Re: Agnico Eagle Mines – Meadowbank Division Responses to Freshwater Intake Station Design Report Comments

- CIRNAC – August 17, 2018, *Crown-Indigenous Relations and Northern Affairs Canada (CIRNAC) Technical Review Comments of the Design Report Fresh Water Intake –Whale Tail Project under Agnico Eagle Mines Limited's Type "A" Water Licence No. 2AM-WTP1826.*
- DFO - August 16, 2018, *Submit comments for project 2AM-WTP1826 for Agnico Eagle Mines Ltd.'s Design Report Fresh Water Intake*

Figure 1: Access road and crane location

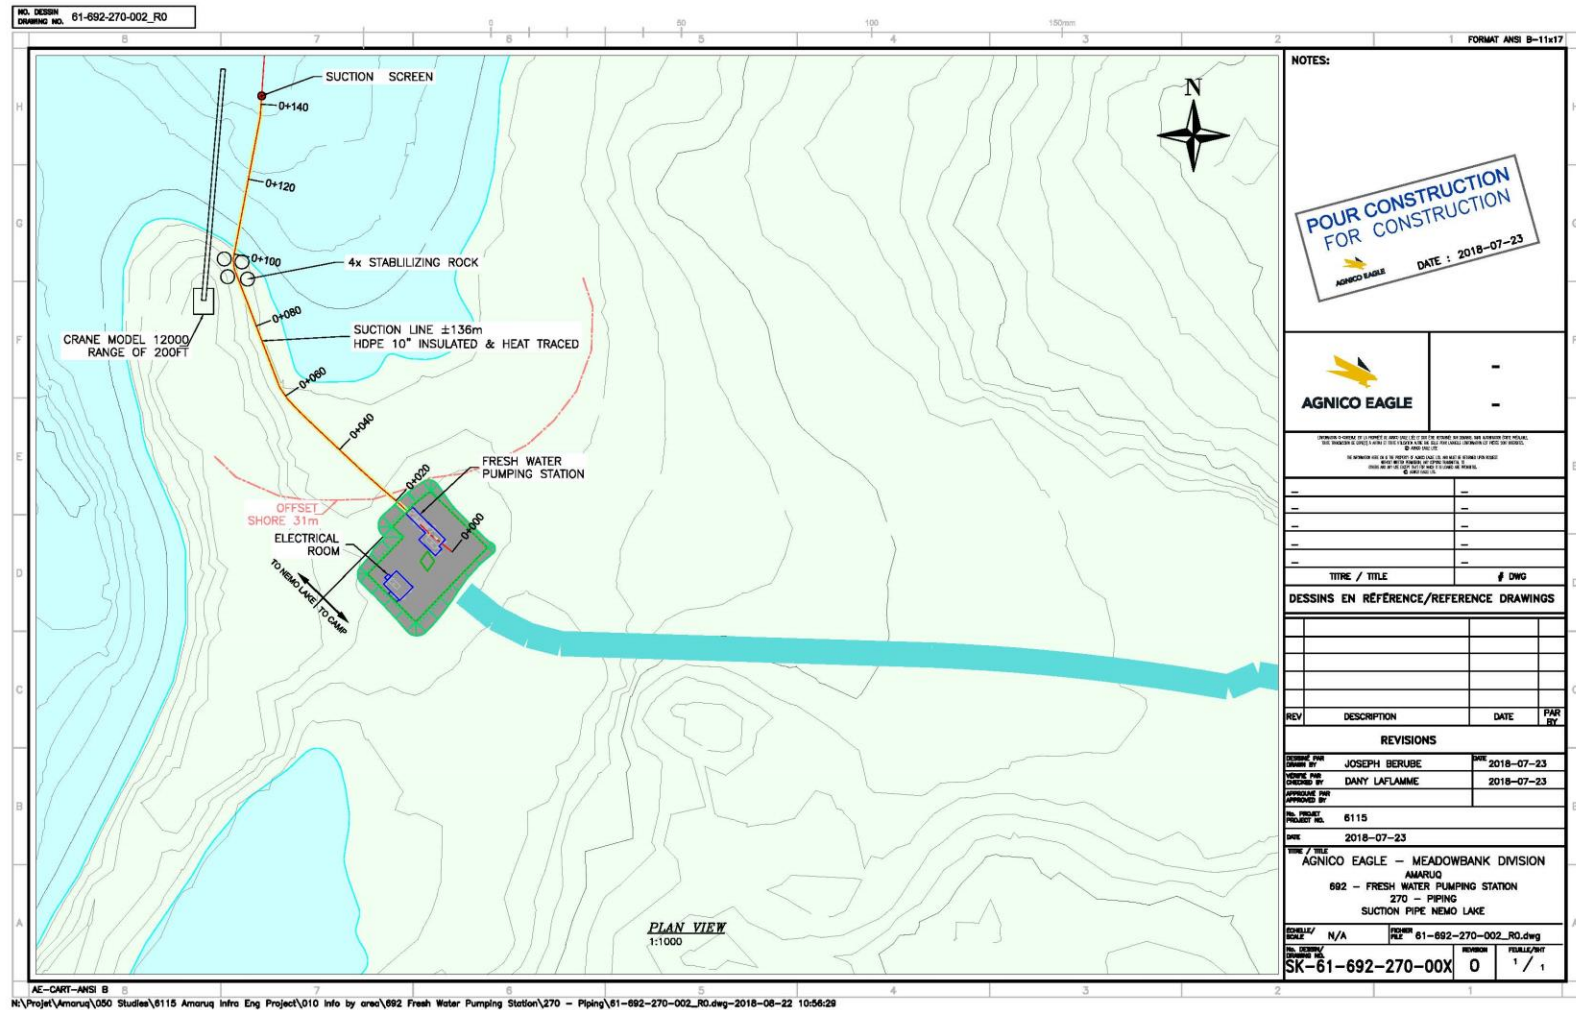
Section 5.1 and 5.2 of the design report describe the assembly and deployment of the on-ground (above) and submarine pipelines. However, there is no description of the equipment to be used, nor demarcation of where the equipment will be permitted to travel, during construction.

CIRNAC requests clarification on how the Licensee plans to minimize disturbance to terrain, permafrost and drainage during construction.

As presented in Figures 1 and 2 below, equipment for construction will circulate on the access road (in blue). The road links the Freshwater Intake Station to the camp. The crane for the placement of the feed pipe into the Nemo Lake will be located close to the pumping pad (see Figure 1). The pipe will be placed into the lake using the crane to limit erosion and sediment suspension in the lake.

BOITE PROTECTION SUCCION
ASSEMBLAGE GÉNÉRAL

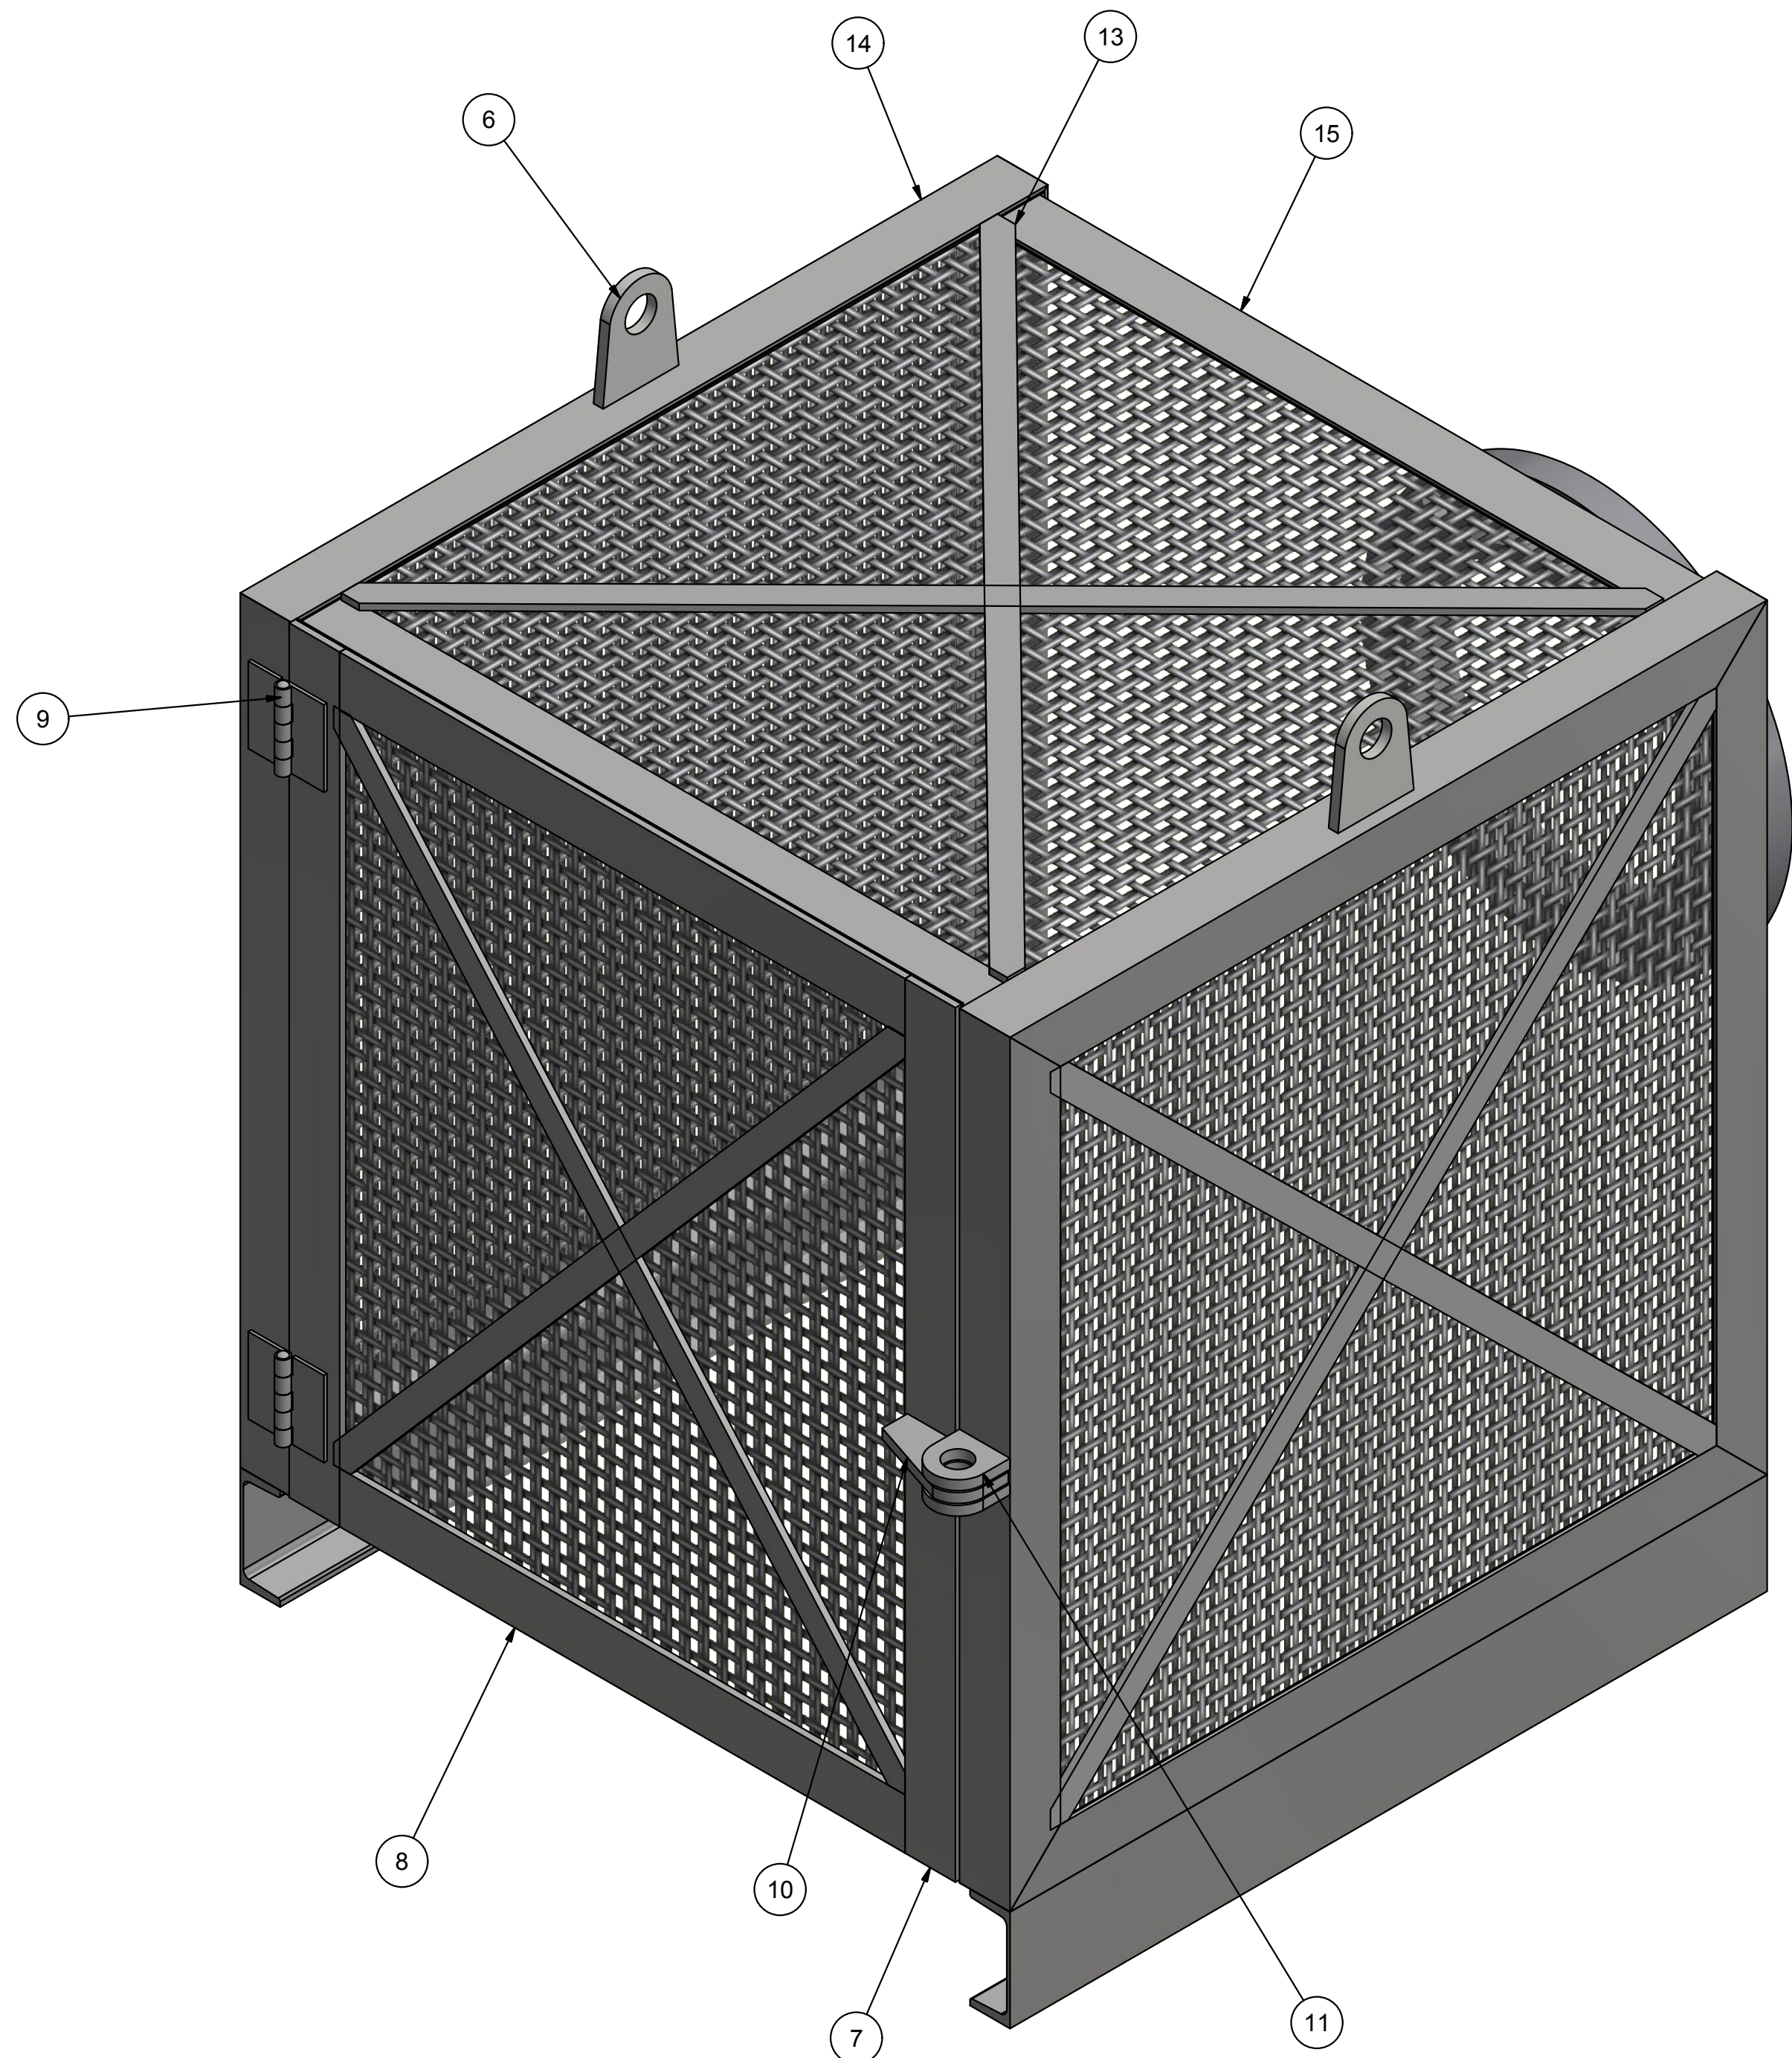
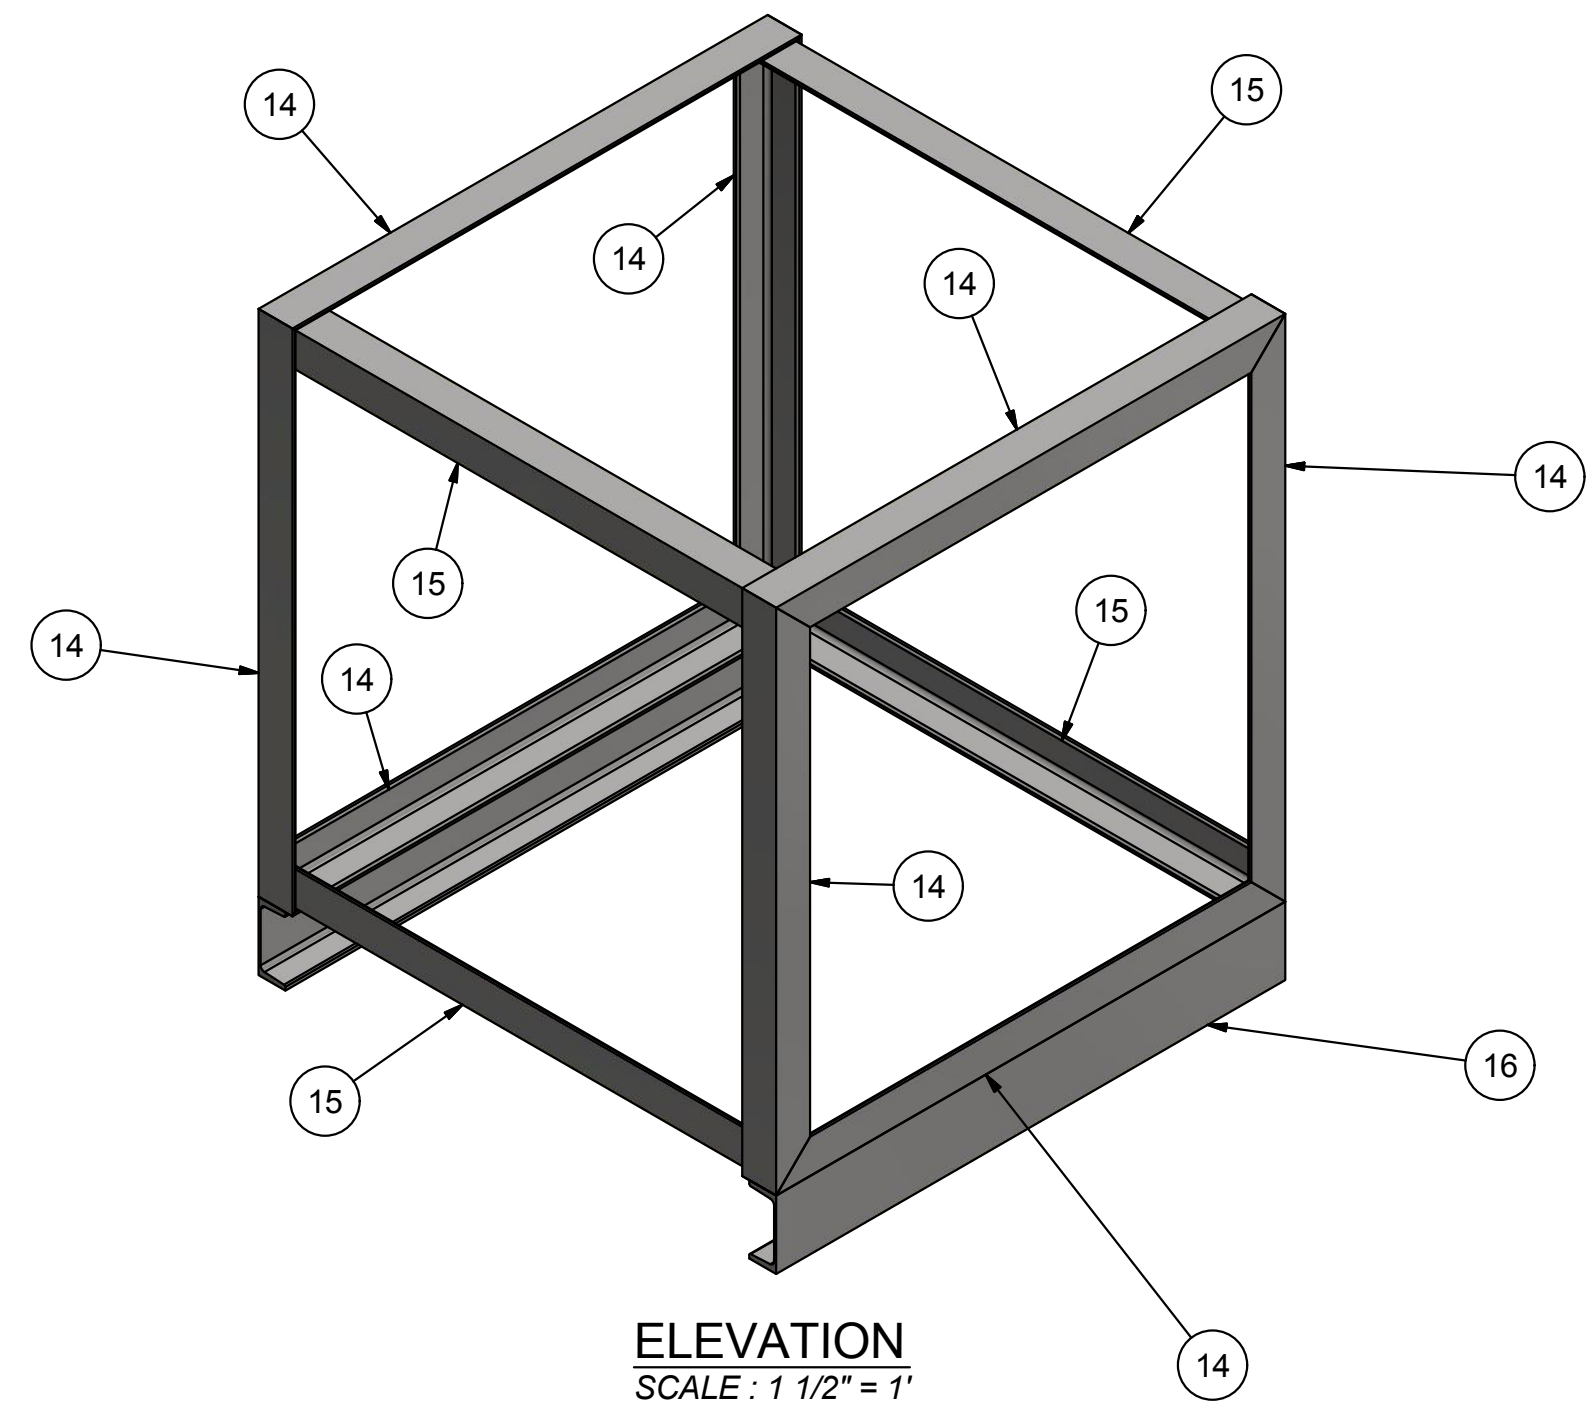
CIRNAC requests confirmation that the screen mesh size used also complies with the Department of Fisheries and Oceans fish screen guidelines.

Comment: DFO-FPP acknowledges that AEM has committed to using fish screens on intakes in an effort to avoid the entrainment and impingement of fishes. However, DFO-FPP is unclear what calculations/ data/ information (i.e., species swim speeds, water intake velocities) were used to determine the appropriate size of screens that were proposed by AEM to avoid the entrainment and impingement of the fish at the intakes and on the screens.

The pumping box has been designed in accordance with DFO's Freshwater Intake End-of-Pipe Fish Screen Guideline. The mesh size selected is ½" (see Figure 3). The design was performed for the anguilliform swimming mode.

The mesh size selected, ½" (see Figure 3), will ensure fish are not entrained. Based on the Freshwater Intake End-of-Pipe Fish Screen Guideline, the area required for anguilliform mode for 550 USGPM is 9.8 ft². For ½" mesh opening, the opening % is 57 %. The required area of sieve is thus 17.2 ft². The suction box is designed for 23.9 ft² sieve area. This will ensure fish are not impinged on the screen/suction box. Detailed engineering of the suction box can be found enclosed with this letter and in Figure 3.
